# Exhibit A

## EXHIBIT A DISCUSSION

**Figure 1.** Sheet A13, Section showing claimed historical grade ("Elevation Line of Natural Terrain") and claimed current grade ("Line of Terrain After Oakshire Ph. (II-III) Development").

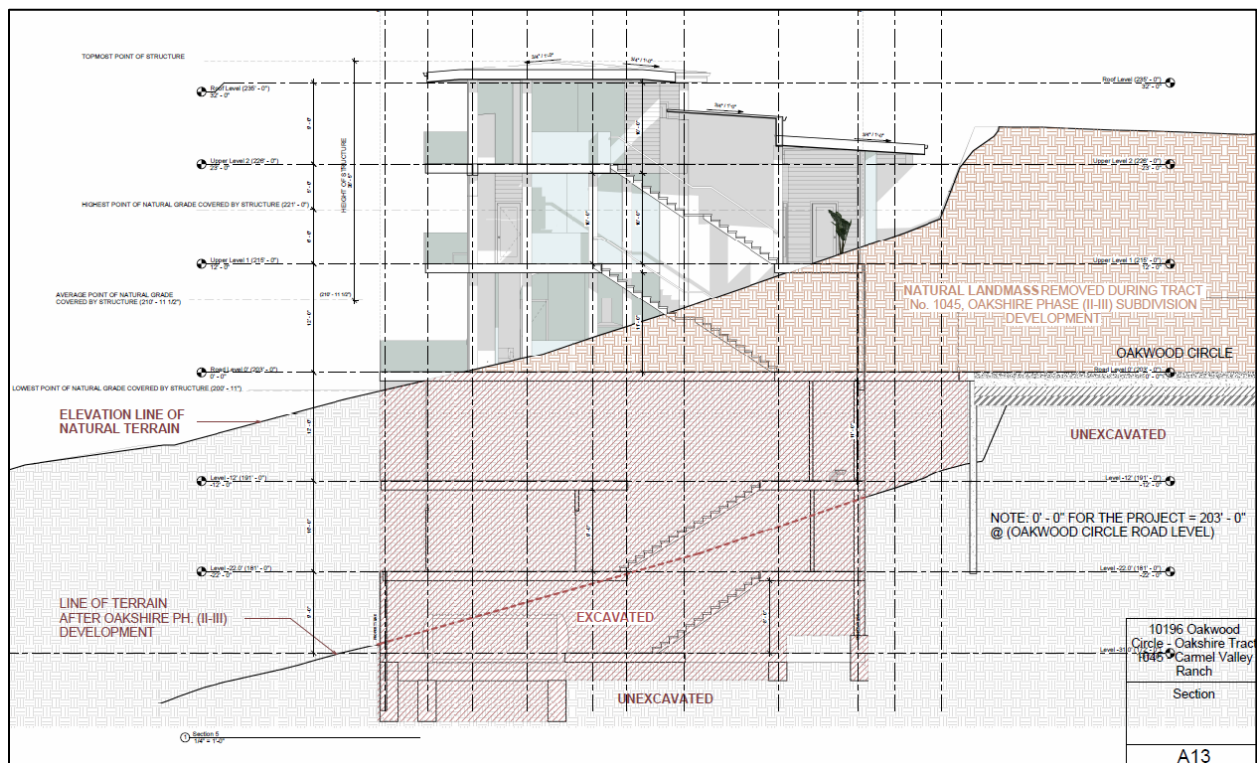
The Applicant/Owner continues to argue their erroneous notion that the existing site conditions differ from historical site conditions. The project plans, specifically Sheet A13, should be updated to only illustrate one existing line of terrain (2023 survey elevations). However, the project plans

continue to illustrate both survey elevations. Nevertheless, although the elevations of the two topographic surveys differ by 27 feet, both surveys represent today's conditions and thus, using the 2016 survey elevations, rather than the 2023 survey elevations, does not have a significant impact on staff's review but does cause general confusion. When reviewing the details of Sheet A13, staff recommends the Planning Commission and the public ignore the "Elevation Line of Natural Terrain" (claimed historical grade) and understand that the "Line of Terrain after Oakshire Ph. (II-III) Development" does represent today's conditions, but the listed elevations should be adjusted 27.12 feet upwards.

**Figure 2.** Project data sheet and corresponding floor plan.

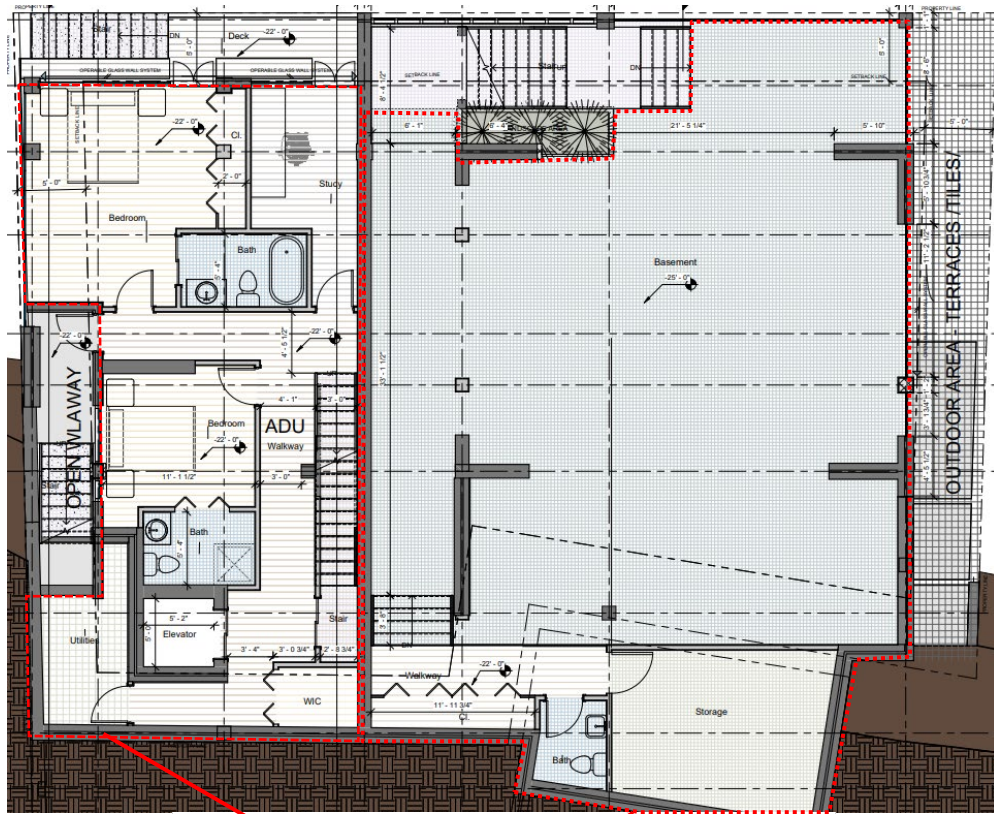
Monterey County Code requires that the square footage of each floor must be "...measured from the exterior face of the enclosing walls." The Project Data table on Sheet A0 identifies the square footage of the residential structure's five levels (Levels 3, 2, 1, -1, and -2). However, as illustrated in the detailed floor plans and elevations (see Sheet A12), the proposed residential structure contains six levels. Therefore, the square footage total listed on Sheet A0 is unrepresentative of the proposed project's total size. Additionally, staff has concerns that the provided square footages are not calculated correctly. For example, the proposed basement shown on Sheet A6 is listed at 385 square feet, however, the adjacent lower level of the proposed ADU, also shown on Sheet A6 and visibly smaller than the basement area, is listed at 800 square feet (see **Figure 2**).

In addition to the Applicant/Owner electing not to provide the sixth (lowest) floor's square footage, the provided square footage appears to be calculated incorrectly. HCD-Planning staff requested that the project plans be updated with the correct square footage information, however, the Applicant/Owner has yet to comply with this request. Based on the Project Data table (see Sheet A0 of **Exhibit B1**), the project consists of a 7,112 square foot six-story single-family dwelling (inclusive of stairs, entry, and elevator) with an attached 832 square foot garage, an attached 1,600 square foot ADU, an attached 483 square foot JADU, and 2,347 square feet of covered and uncovered decks, for a total square footage of 12,374 square feet. Given the apparent inconsistencies of Sheet A6, staff manually calculated the floor area for the entire structure using the provided ¼ inch to 1-foot scale. Per staff's rough calculations, the project consists of a 12,469.5 square foot six-story single-family dwelling with an attached 934 square foot garage, an attached 2,124 square foot ADU, an attached 483 square foot JADU, and 3,419.5 square feet of covered and uncovered decks, patios, and exterior staircases, for a total square footage of 19,430 square feet. Staff's calculations indicate that the residential structure is approximately 7,056 square feet larger than the Applicant's calculations.

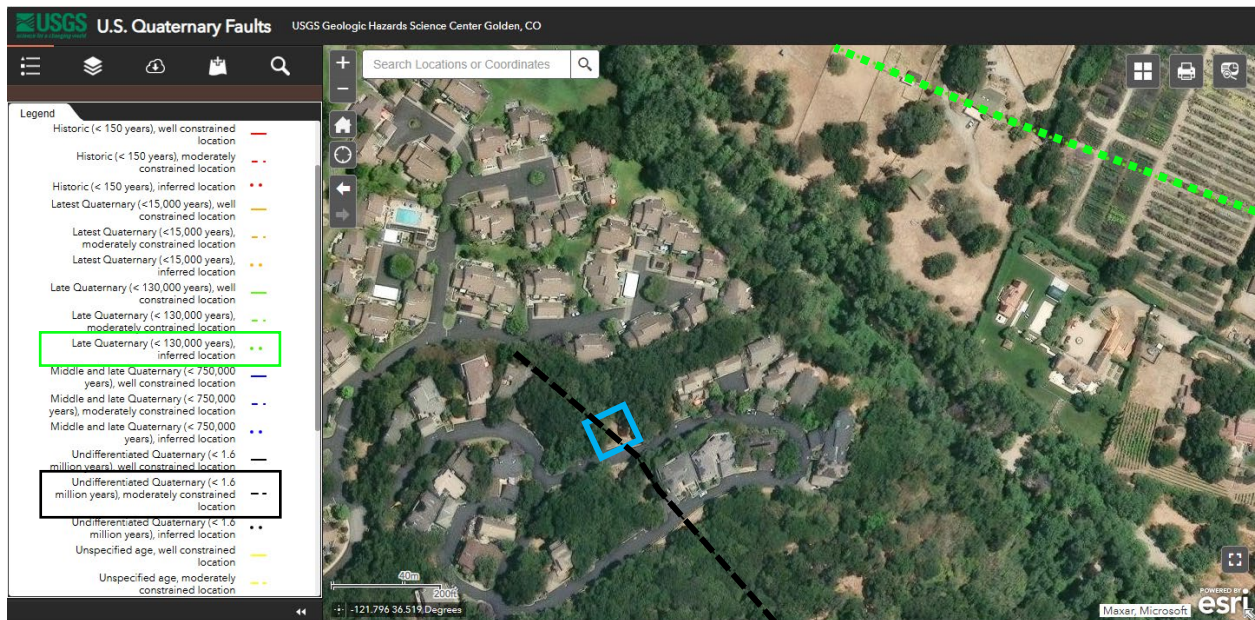
Without a project-specific geological report, there is substantial evidence in the record, namely State and Federal mapping, that indicates the proposed project would be constructed on an active or potentially active fault. Should development occur on this site, there is no evidence that the property’s geological hazard has been reduced to an acceptable level. Therefore, without a site-specific geological report, the proposed project poses a potentially significant threat to its occupants and the surrounding neighborhood’s health, safety, and general welfare.
